# Service Bulletin

MOTORCYCLE	
ISSUE NO.	: M-4-0507
DATE	: Mar. 10, 2010
PAGE	: 1 OF 3

SUBJECT	: CORRECTION OF SERVICE MANUAL
APPLICABLE MODEL	: VZR1800K6-K9, VZR1800ZK7-K9 and VZR1800NK8-K9
EFFECTIVE ENGINE OR FRAME NO.	:
REFERENCE	: E-02, 03, 19, 24, 28, 33, 51

<b>SUBJECT</b>	<b>: CORRECTION OF SERVICE MANUAL</b>
<b>APPLICABLE MODEL</b>	<b>: VZR1800/Z/N/UF/ZUF/NUFK6 – L0</b>
<b>EFFECTIVE ENGINE OR FRAME NO. :</b>	
<b>REFERENCE</b>	<b>: E-02, 03, 19, 24, 28, 33 and 51</b>

### Page 3-44

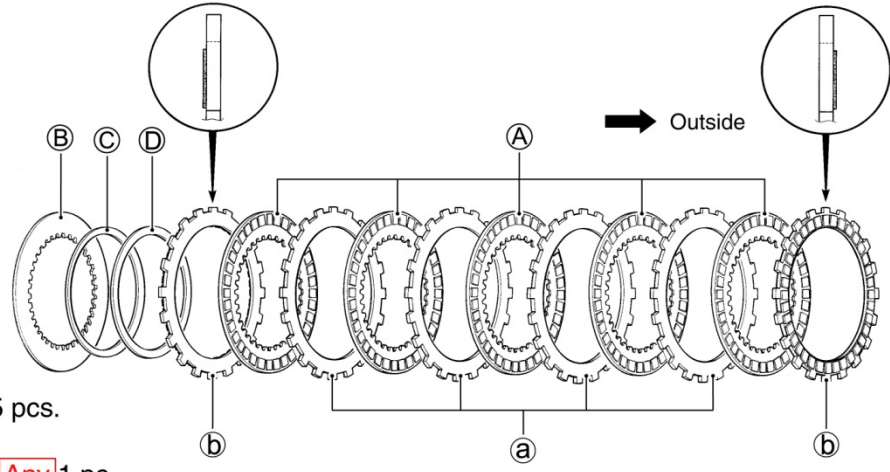
#### Clutch plate distortion

(drive plate No.2 and driven plate No.1)

Service limit: 0.01 mm (0.004 in)

#### Clutch plate distortion

(drive plate No.2 - No.4 and driven plate No.1)

Service limit: 0.01 mm (0.004 in)

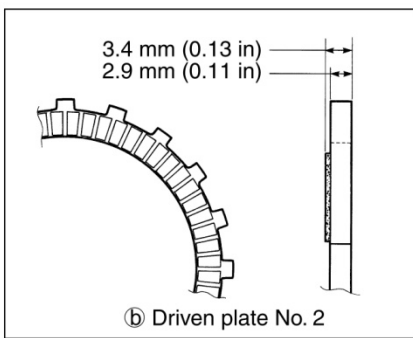
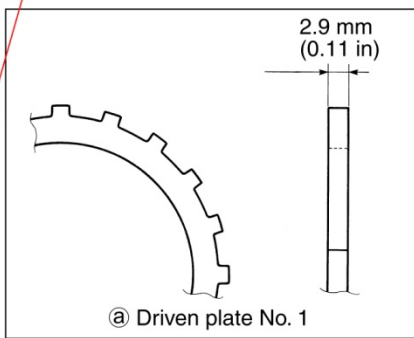
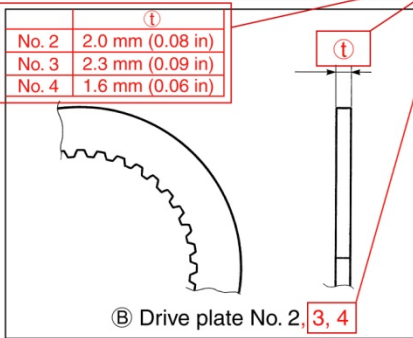
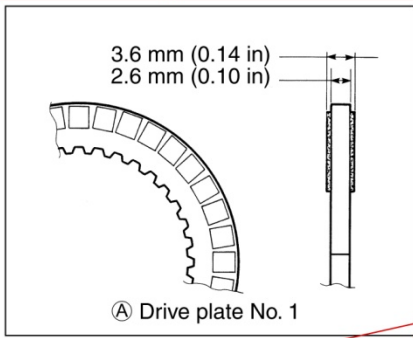
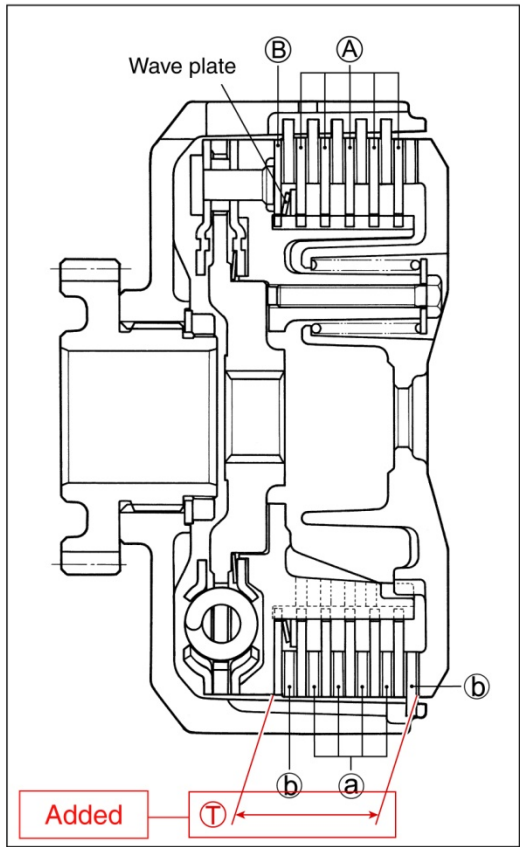
- Ⓐ Drive plate No. 1 .....5 pcs.
- Ⓑ Drive plate No. 2 .....Any 1 pc.
- Ⓒ Wave washer .....Added
- Ⓓ Wave washer seat

- Ⓐ Driven plate No. 1 .....4 pcs. Added
- Ⓑ Driven plate No. 2 .....2 pcs.

**NOTE:**  
 \* Basically in this motorcycle, the drive plate No. 2 is installed as shown Ⓑ. Instead of the No. 2, however, sometimes the drive plate No. 3 or No. 4 may have been installed at the factory for the purpose of fine adjusting the overall thickness ① of clutch plates. When replacing the plate Ⓑ in the aftermarket, always use the drive plate No. 2.

## **FUEL INJECTOR INSTALLATION**

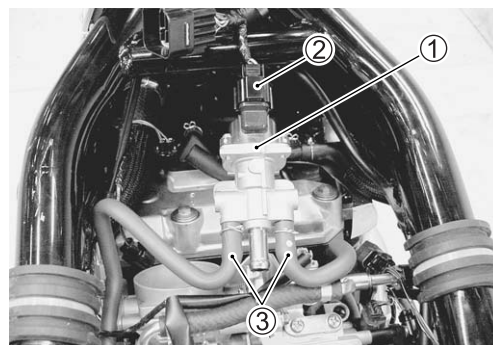
- Apply thin coat of the engine oil to new injector cushion seals and O-rings. (🔧 6-20)
- Install the injector by pushing it straight to the throttle body. Never turn the injector while pushing it. (🔧 6-20)

### **MODIFIED**

**MODIFIED****Step 2**

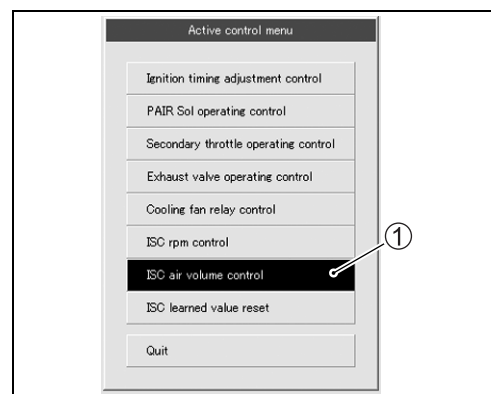
- Set up the SDS tool. (5-25)
- Start the engine.
- Click “Data monitor”.

Check that DTC No. P1750 and P0105 are monitored.

- Warm up the engine (Water temp. more than 70 °C (158 °F)).

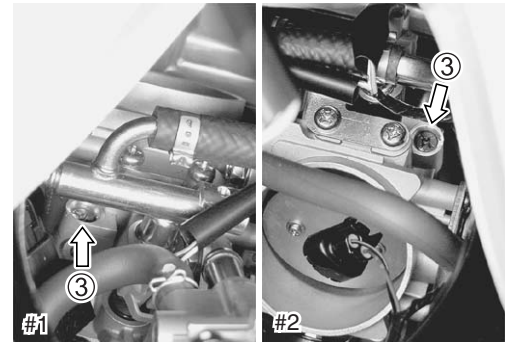
**MODIFIED**

- Equalize the vacuum of the cylinders by turning each air screw ③ and keep it running at idling speed.

*Always set the engine rpm at idle rpm.*
